Philadelphia Electric Company

Limerick Plant

Control Room Design Review

Final Report

Figure 2-7. Viewing Distance to Back Panel Area

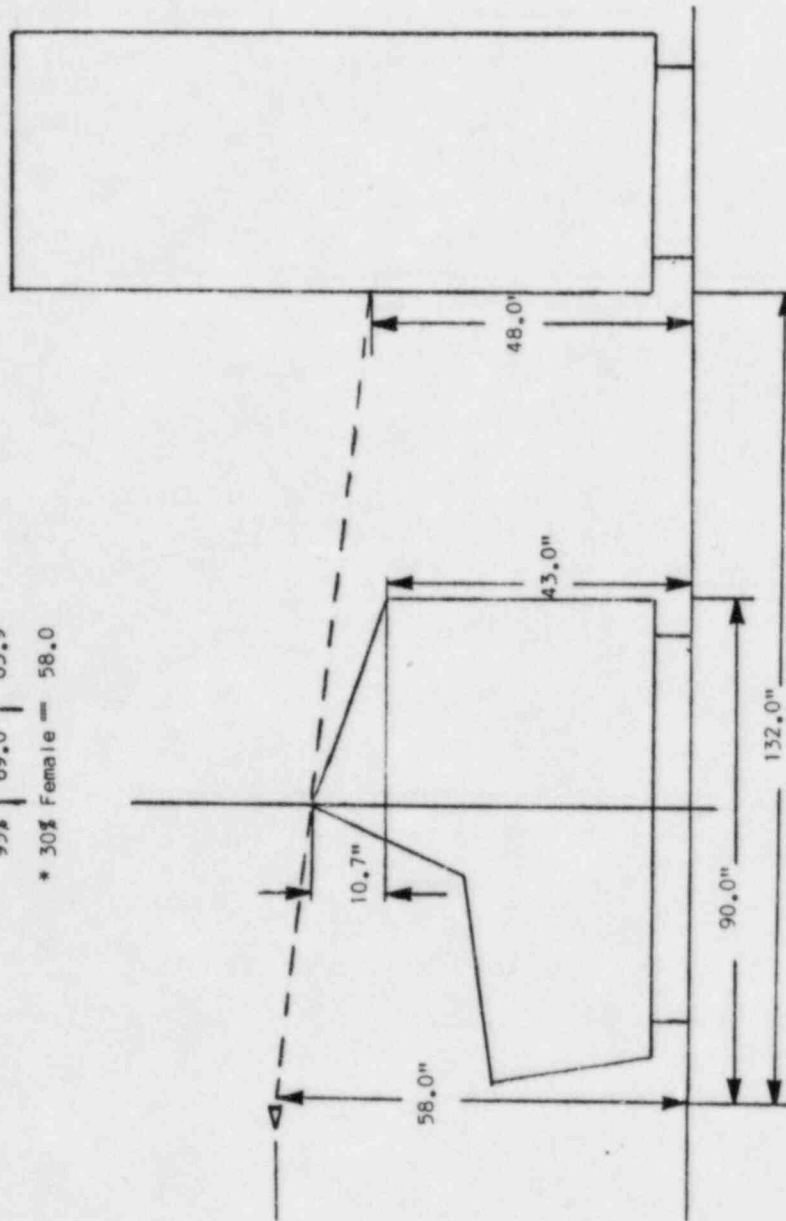
The potential problem with visibility of the lower portion of the vertical boards behind the consoles by the operator standing at a normal work station in front of the console was discussed previously in 2.1.2 Workspace and Environment (see Figure 2-7).

The review revealed no instances where it would be necessary to move the control or indication, or to add an annunciator alarm. Related indicators and recorders are visible to alert the operator well before a response is required. These related indications were determined to provide at least as much alert to the operator as if the direct indication or control in question were observed. For the ECCS panels, all instruments and controls were observable by the operator when at his emergency station.

Figure 3-1. Before and After Control Panel Enhancements

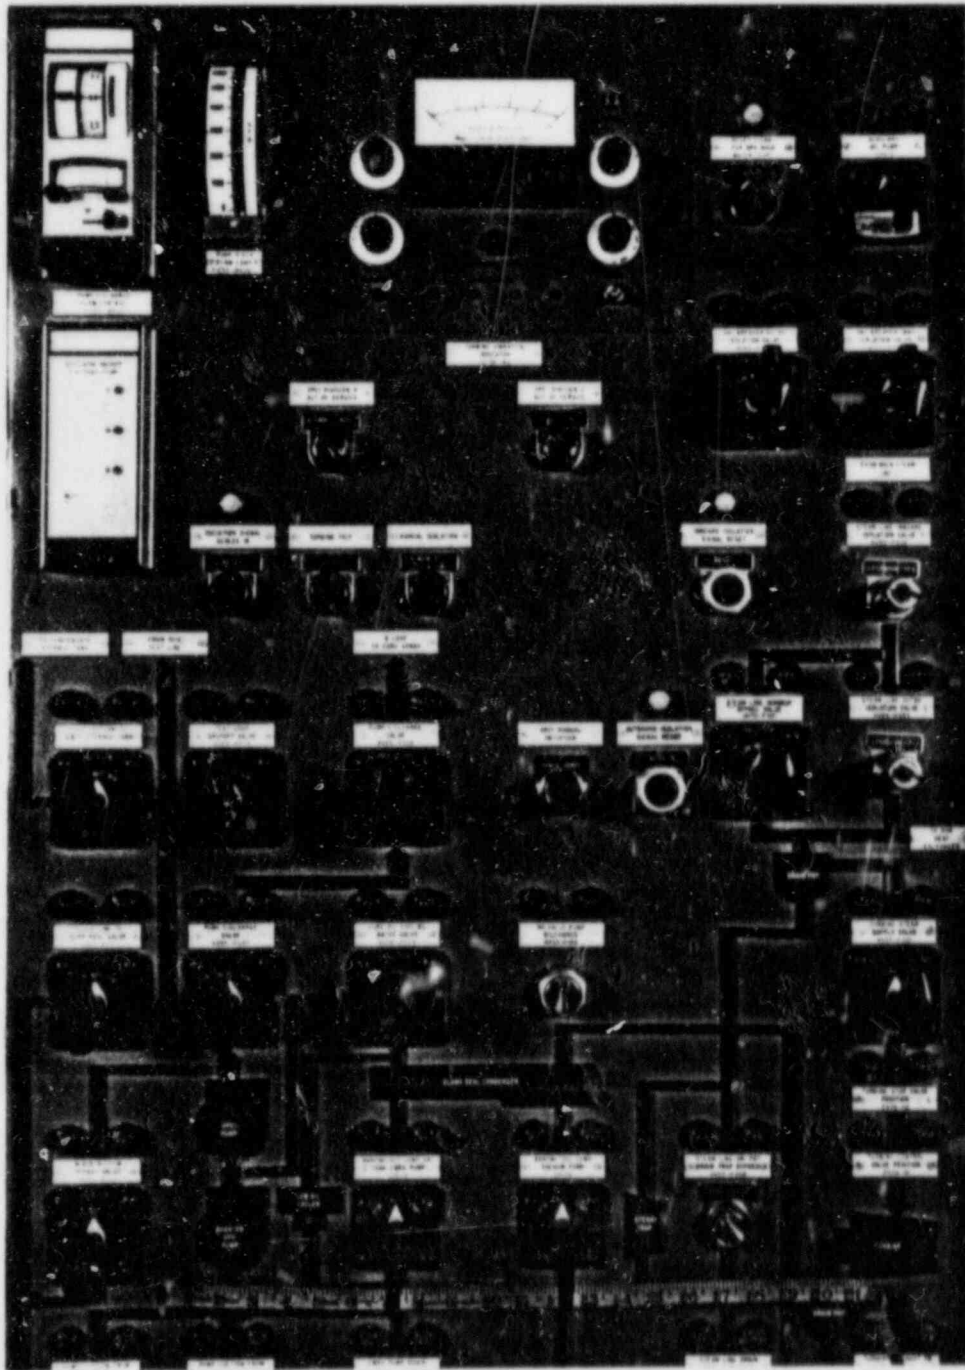
Examples of control panel enhancements to be implemented are shown in Figure 3-1. This figure shows before and after enhancement photographs of various control panels as implemented on the control room mockup. It is considered that these enhancements fully correct the problems of grouping and demarcation. Some changes in component locations are specified for the final enhancements. Where these changes will be accomplished after fuel load, an interim enhancement design has been completed and will adequately serve until the final configuration can be obtained.

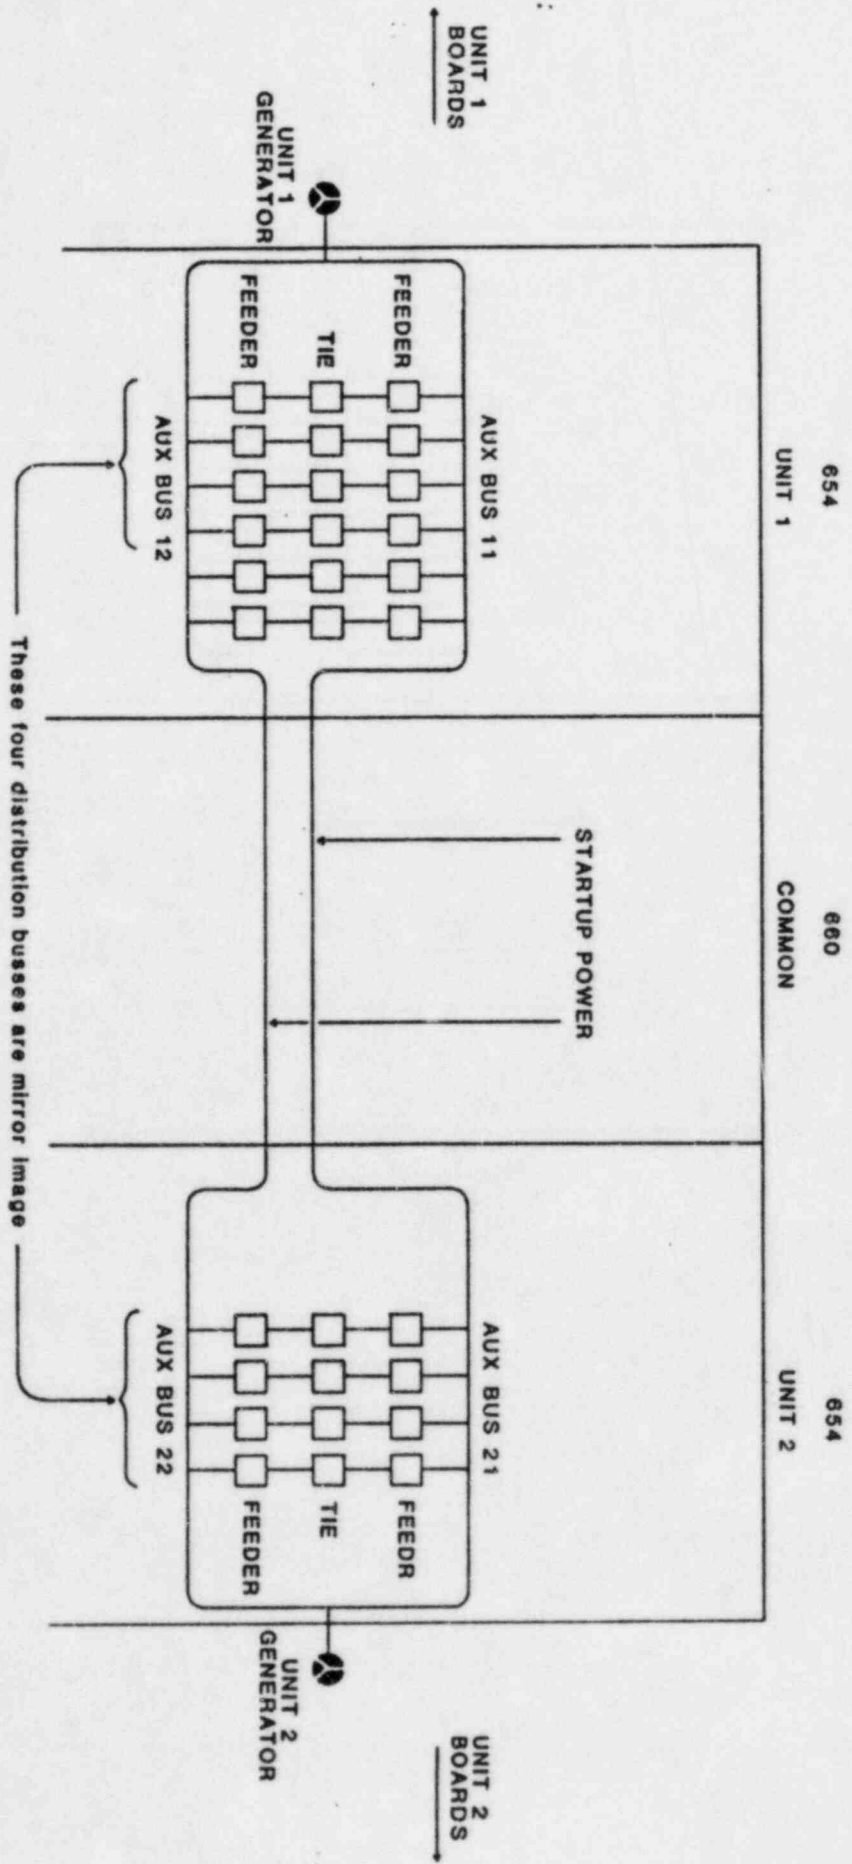
COMMENT: The generator and auxiliary power panels are mirror-imaged.

These panels are arranged on either side of 660 (Start-up power). This arrangement is to indicate the distribution network of start up power to each unit (see attached). The mirror imaging effects are minimized and compensated for by the design of enhancements, which clearly indicate the load centers and aux bus distribution mimicing. The arrangement is not considered a detriment to operator performance.
